# CITY OF SILOAM SPRINGS BOARD OF ADJUSTMENT

(Special-Called)

## AGENDA

# STAFF REPORT

94"x144" Double Sided Monument sign

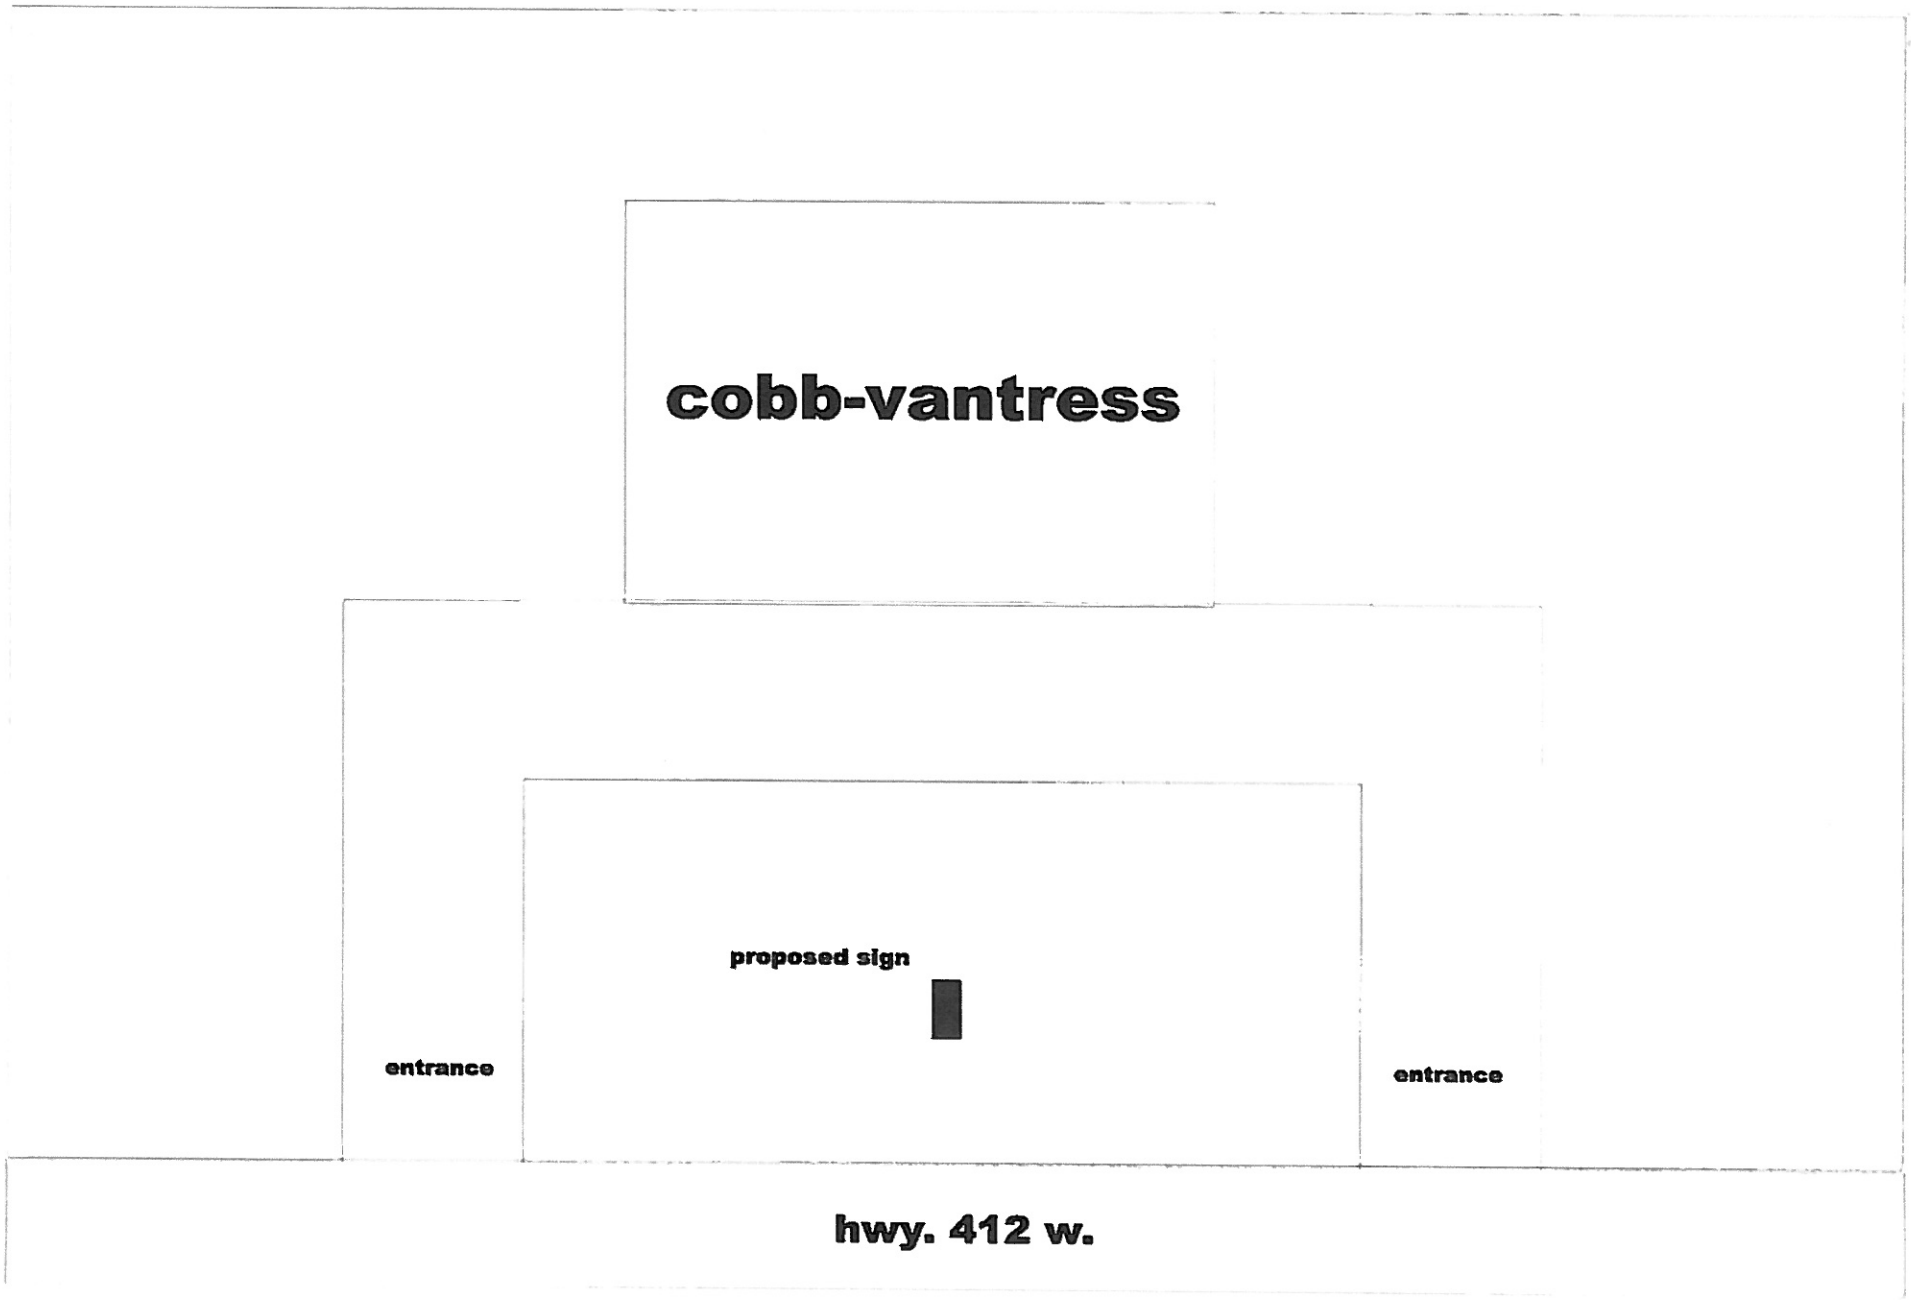
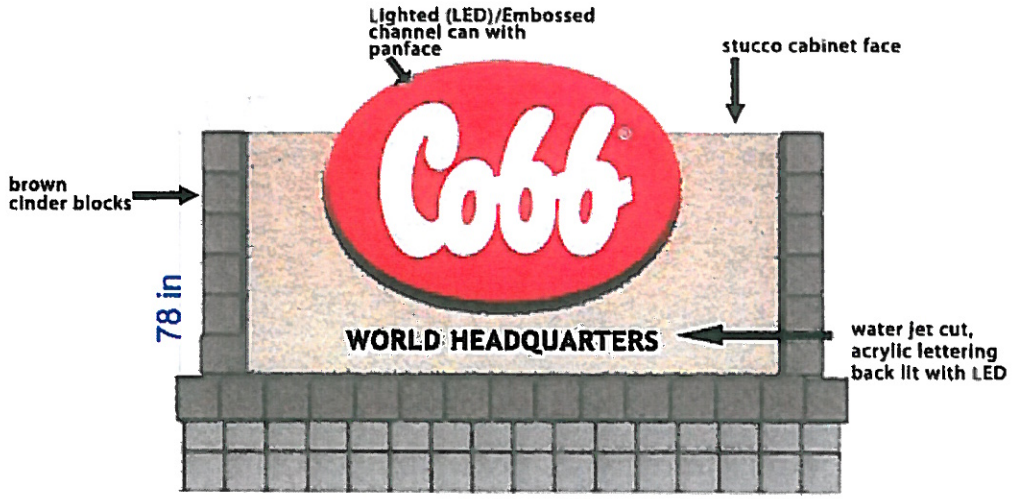
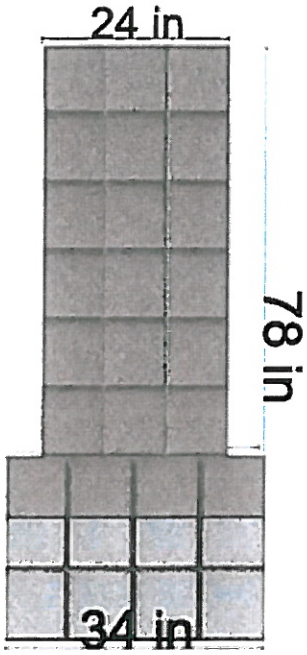
PROJECT INTENT
The applicant desires TO CONSTRUCT FREESTANDING MONUMENT SIGN IN AN I-1 (INDUSTRIAL) ZONE AND TO ILLUMINATE THE SIGN BY DIRECT ILLUMINATION. This is a direct code violation of Section 81-39.2 and 81-39.2(1) of the Municipal Code.

The applicant desires to construct a new freestanding monument sign at the location of the corporate headquarters of Cobb-Vantress, Inc., a poultry processing industry. The offices and processing facilities are located on abutting lots, all associated lots are zoned I-1 (Industrial). I-1 allows for both industrial office uses and processing. Signage is permitted in industrial zones, but monuments signs are not. This is more than likely an assumption that the headquarters of an industry, being more office use than industrial processing, would be zoned C-2, which would permit such signs. Incidentally, it is unclear

In the next Sign Code update, staff intents to add industrial zones to the allowed zones permitting monument signs. The fact that these signs are prohibited in industrial zones is more than likely the assumption that industrial uses would not disburse the added expense for these types of signs. This is clearly not the case and the City encourages the use of these signs as much as possible to improve the overall aesthetics of Hwy. 412 and other areas. It could also be argued that the practical difficulty, in this case is the restriction of sign design options available to the applicant, particularly in the case where a company's headquarters desires to use an upgraded sign display to reflect their image to their customers and the community. Therefore, prohibiting monument signs creates practical difficulties on the applicant. Staff believes permitting a monument sign at this location is in keeping with the general spirit and intent of the Sign Code. Staff concurs that the applicant has provided a compelling argument against indirect sign illumination. Staff believes there can be arguments made on either side of the issue, but is willing to take the issues raised by the applicant under consideration. It is assumed that the Code restricts lighting to indirect only primarily for aesthetic purposes, but given the preponderate signage along Hwy. 412, an internally lit sign will not be out of character with the neighborhood, or detrimentally impact surrounding properties. Due to the Sign Code limitations aforementioned, staff believes the applicant has legitimate hardships.

# LOT LINE ADJUSTMENT

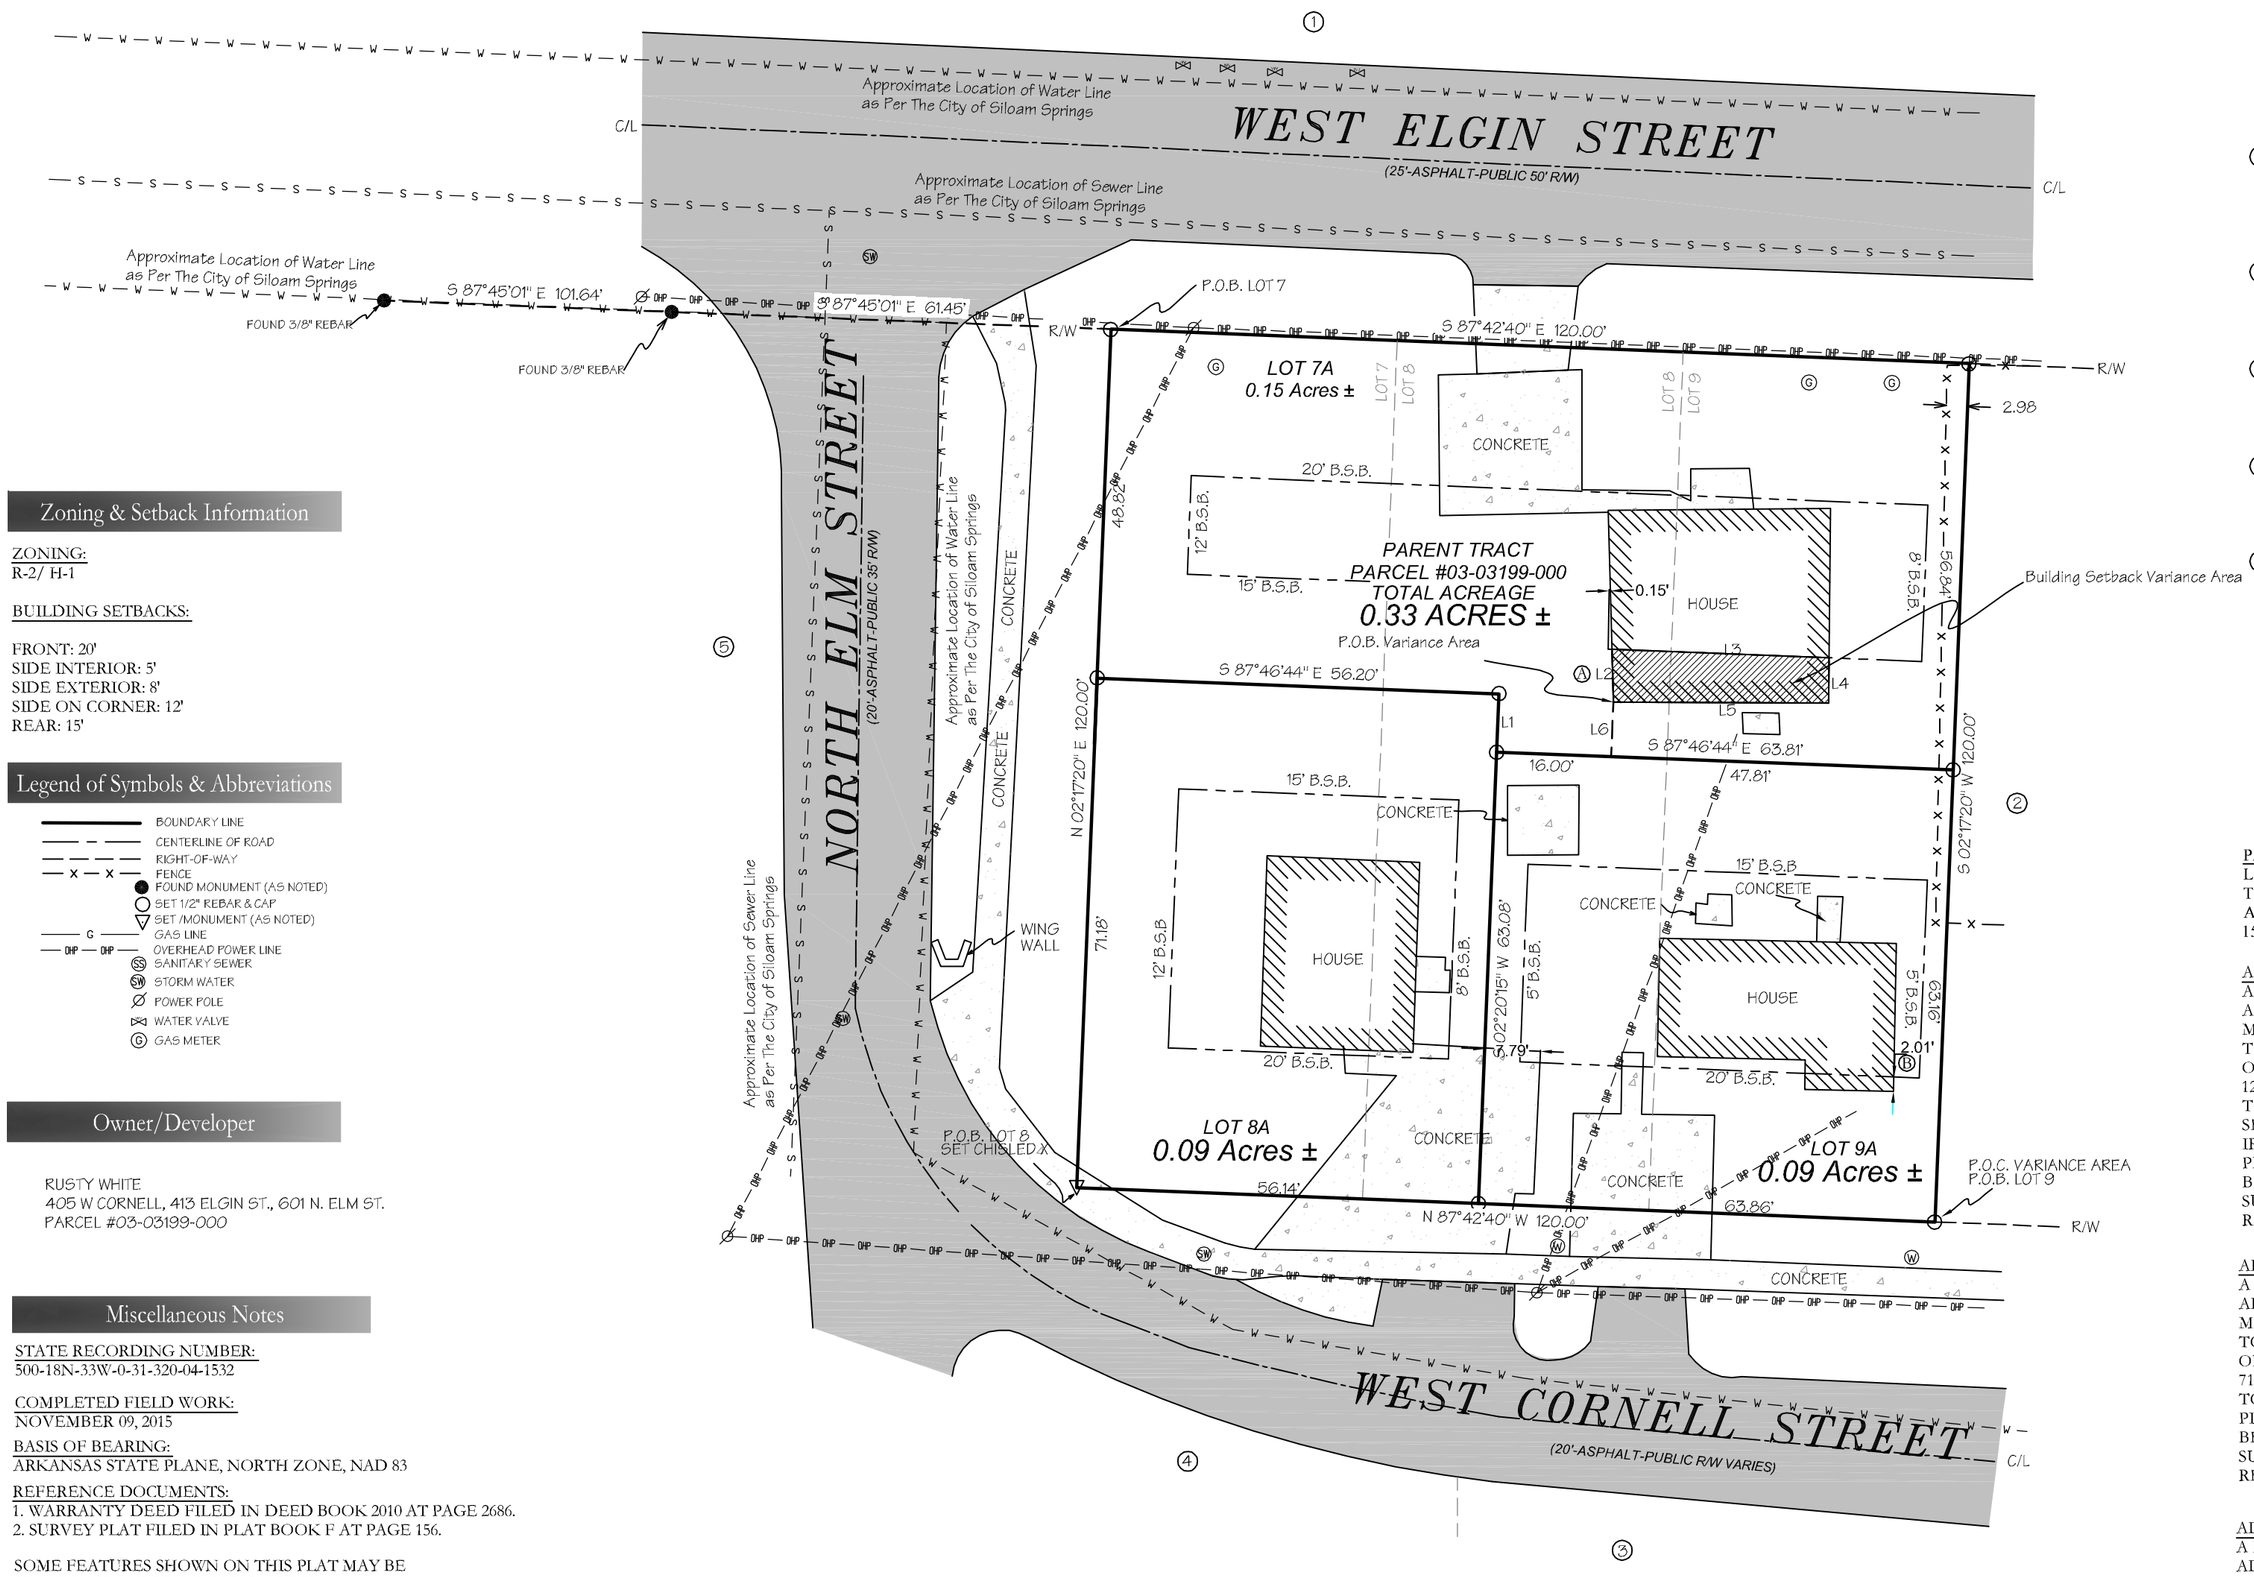
PROJECT INTENT
The applicant desires TO PLAT NEW LOT LINES THAT CAUSES A 6.89 FEET STRUCTURAL ZONING SETBACK ENCROACHMENT IN THE REAR OF TRACT 7A AND TO PLAT A NEW LOT LINE THAT CAUSES A 4 FOOT (COMBINED) DRIVEWAY SETBACK ENCROACHMENT. This is a direct code violation of Section 102-50(d)(1)(e) and 102-50(e)(1)(a).

The applicant is requesting to re-plat lots 7-9 in Block 9 of the W.M. C. Tates Addition. This block is located north of Cornell St., east of N. Elm St., and south of W. Elgin St., due south of Northside Elementary School. The purpose of this re-plat is to adjust the size and orientation of the three lots so that three existing single-family residences are located on their own lots. Presently these houses are straddling the existing lot lines. The re-platting effort will improve the existing setback encroachment issues, however, due to the minimum lot size requirement of 4,000 sq. ft., the H-1 property line to building setbacks cannot be maintained, even after adjusting the lot lines. The requested variances are to allow the existing house, addressed as 413 W. Elgin, located on the proposed Lot 7A, to encroach by 6.89 feet into its rear yard setback, and to add a property line which causes encroachments on the 2 ft. residential driveway setback. Due to the existing driveway locations and house locations, it is impossible for this line to be drawn in a manner that would maintain the 2 foot driveway setback and also maintain the necessary lot sizes. Lot 8A and 9A are both at the minimum lot size requirement of 4,000 sq. ft. A variance is not possible for reducing the lot size due to Section 102-3(c) of the Municipal Code. This Code section states that no lot may be smaller than permitted, allowing an otherwise greater housing density than allowed in the base zone.

The applicant states in their Statement of Hardship that because the houses are pre-existing and have been in place prior to the adoption of the current zoning regulations, and that the houses sit on a street corner, there are sufficient reasons why the setbacks cannot be honored notwithstanding any proposed lot configuration. Staff concurs that the existing conditions do not lend for a proposed lot configuration that would allow each existing house to have its own lot and be the minimum lot size, and yet still meet all H-1 setbacks. Therefore, if the effort of this request is to reduce existing non-conformities, in this case allowing each house to have its own lot, staff believes the applicant has presented sufficient hardships to warrant a both the building setback and driveway setback variances. The key point to note in this case is that all structures, driveway and the house, both exist (not proposed).

Ⓐ HOUSE GOES OVER SETBACK BY AS MUCH AS 6.89'

Ⓑ HOUSE GOES OVER SETBACK BY AS MUCH AS 2.01'

# Variance Exhibit 1 of 2

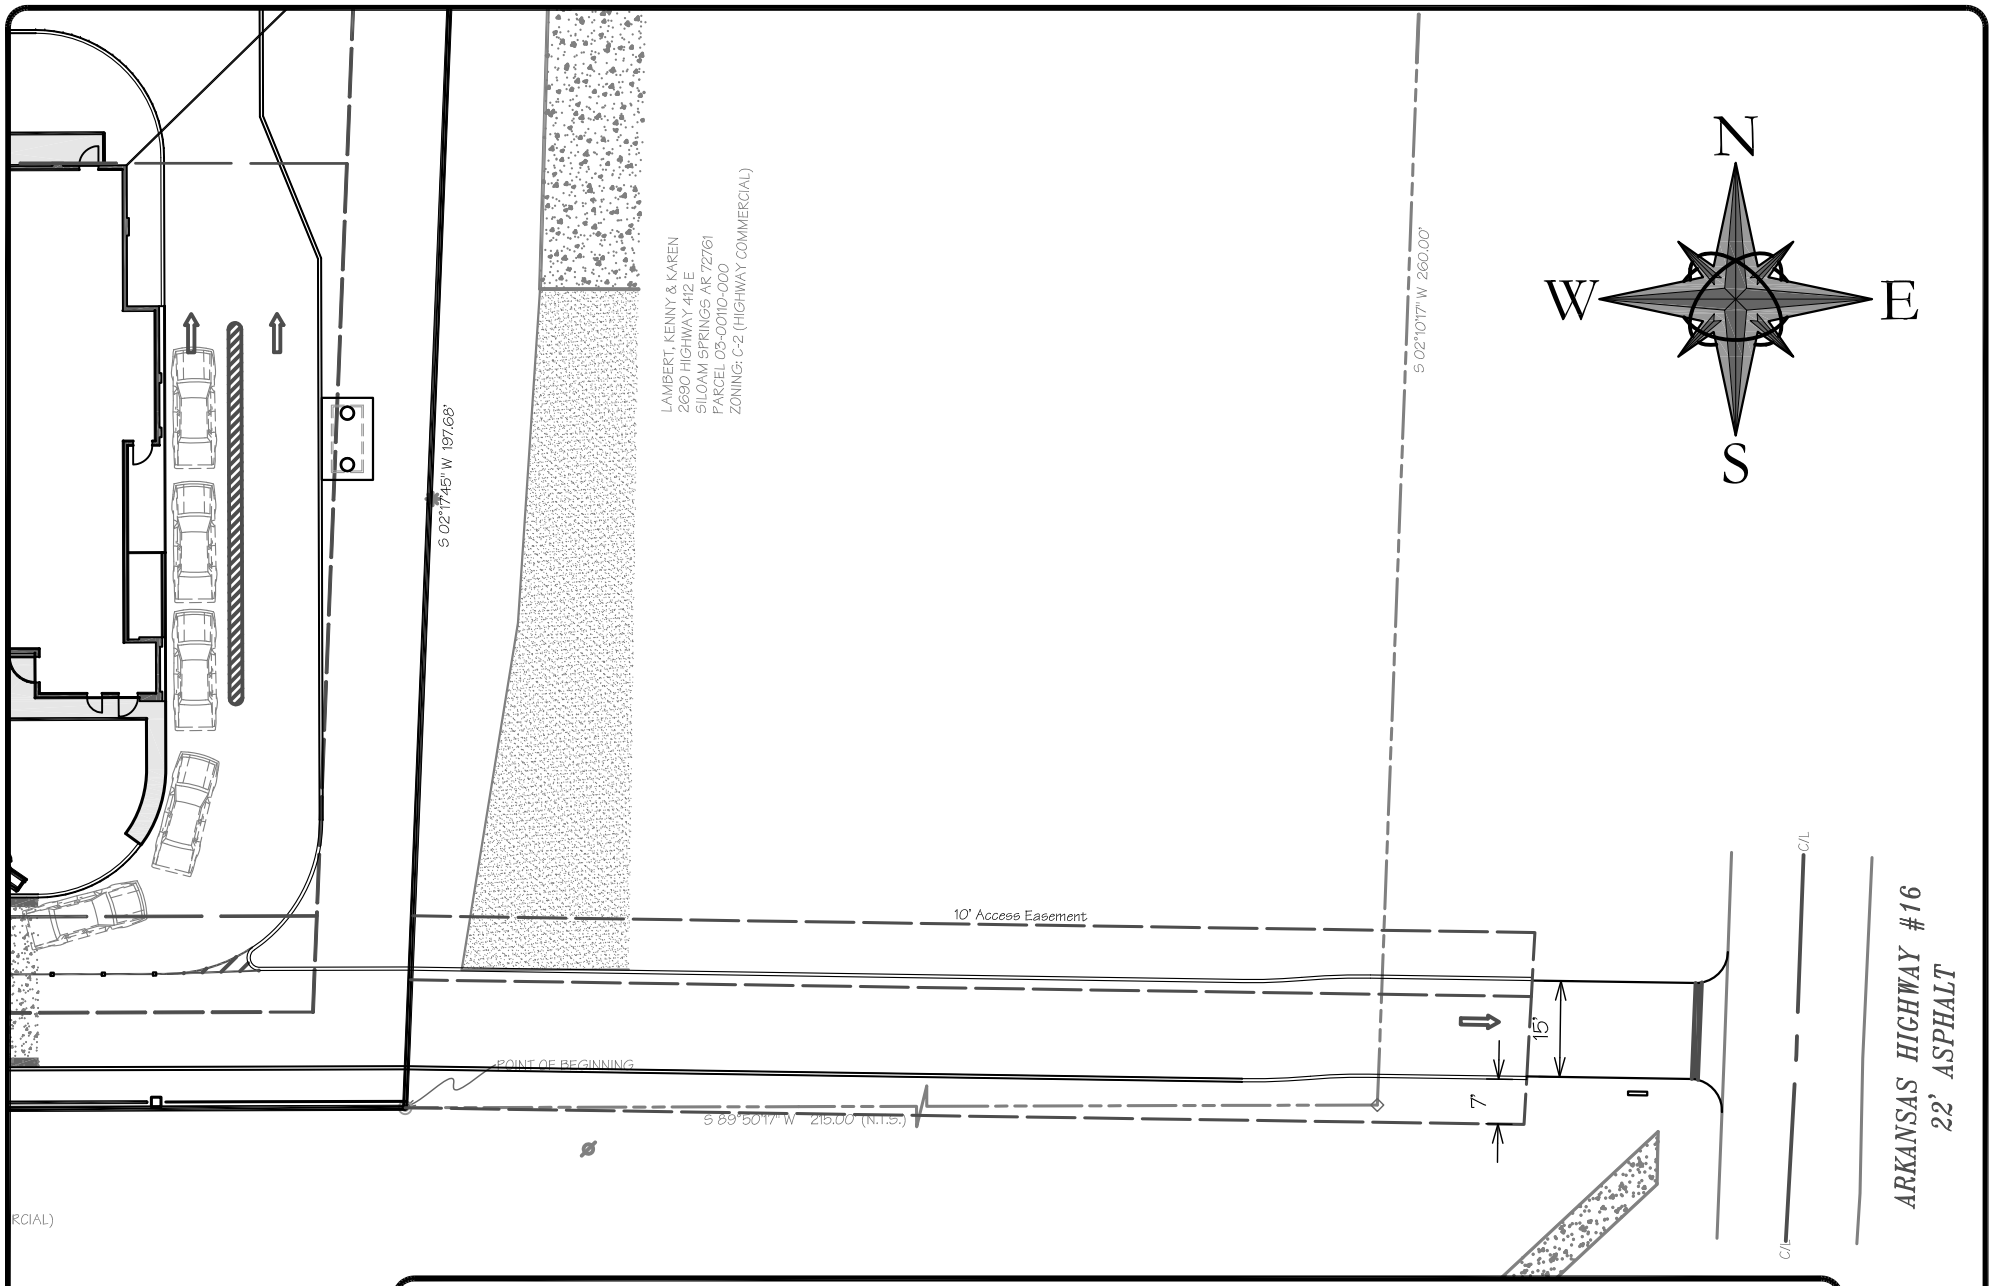
The first Code violation is related to the driveway to property line setback. The new Zoning Code requires this to be 50 feet from the boundary line of the lot, in cases when the driveway is accessing an arterial street class or higher, as defined by the City's Master Street Plan. The drive in question is on

the southern side of the lot and is intended to be a one-way exit drive onto Hwy. 16 via an existing 20 ft. access easement which burdens the lot to the east of the subject property. Because of the limited depth of the lot, when factoring in the placement of a drive-thru lane, parking and the building placement, there appears to be no feasible way to allow the drive to be offset by 50 feet from the rear property line. Furthermore, the nature of the access easement is such that it burdens the lot to the east on its southern property line, so in order to make use of this easement, the applicant is forced to construct the drive within this rear setback. After review from City staff, there appears to be no negative impacts on traffic if this variance is granted.

The drive will align with an existing bank drive on Hwy. 16. If the 50 foot setback was honored, this drive alignment would be impossible, further complicating the traffic interaction of both drives. Therefore, it could be argued that the proposal is safer than what would occur if the drive setback was honored in this case. The applicant states that the drive is needed for improved ingress and egress, especially for vehicles during to travel west, as making a left turn on Hwy. 412 would be impossible when a future planned median is constructed as part of a potential future widening of Hwy. 412 in this area.
